# Access Compliance Report

## Public Rights-of-Way

### (Curb Ramps)

Intersection ID: 49507	Main Street: OSCEOLA_LN	Cross Street: ANKENY_CT	Location:	N
ADA ID: C078AC584698	Ramp Type: PerpDiag	Initial Pass/Fail: Fail	Overall Compliance: No	Severity Score: 46.25
Codes/Mitigation Info/Possible Solution		Field Measurements/Component Compliance

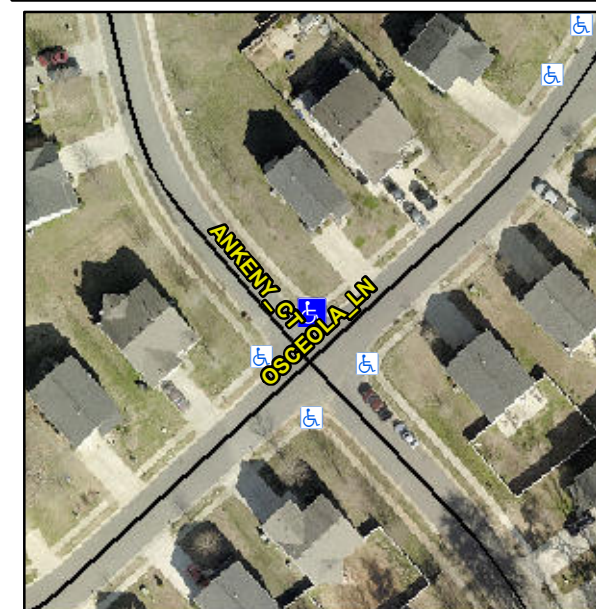
**Not Found, R304.5.1, R304.2.2, R304.5.3**

Compliance	Description	Data	Compliance	Description	Data
N/A	Ramp Length (in)	48.0	No	Ramp Slope (%)	17.0
No	Ramp Width (in)	44.0	No	Ramp XSlope (%)	6.8
N/A	Flare Type LT	N/A	N/A	Flare Type RT	N/A
N/A	Flare Slope LT (%)	N/A	N/A	Flare Slope RT (%)	N/A
N/A	Flare Traversable LT?	N/A	N/A	Flare Traversable RT?	N/A
N/A	Landing Length (in)	N/A	N/A	DWS Provided?	N/A
N/A	Landing Width (in)	N/A	N/A	DWS Contrast?	N/A
N/A	Landing Slope (%)	N/A	N/A	DWS Length (in)	N/A
N/A	Landing X Slope (%)	N/A	N/A	DWS Full Width?	N/A
N/A	Landing Curb? (Y/N)	N/A	N/A	DWS Offset (in)	N/A
N/A	Shared Landing?	N/A			
N/A	Gutter Ponding?	N/A	N/A	Gutter Slope (%)	N/A
N/A	Gutter Lip Ht (in)	N/A	N/A	Gutter X Slope (%)	N/A
N/A	Painted X Walk1?	No	N/A	Painted X Walk2?	No
	X Walk 1 Direction	To SW		X Walk 2 Direction	To SE
N/A	X Walk 1 Width (in)	N/A	N/A	X Walk 2 Width (in)	N/A
	X Walk 1 Slope (%)	7.6		X Walk 2 Slope (%)	6.5
	X Walk 1 X Slope (%)	0.8		X Walk 2 X Slope (%)	7.2

**Remove & Replace Curb Ramp With Two New Directional Ramps or Equivalent.**
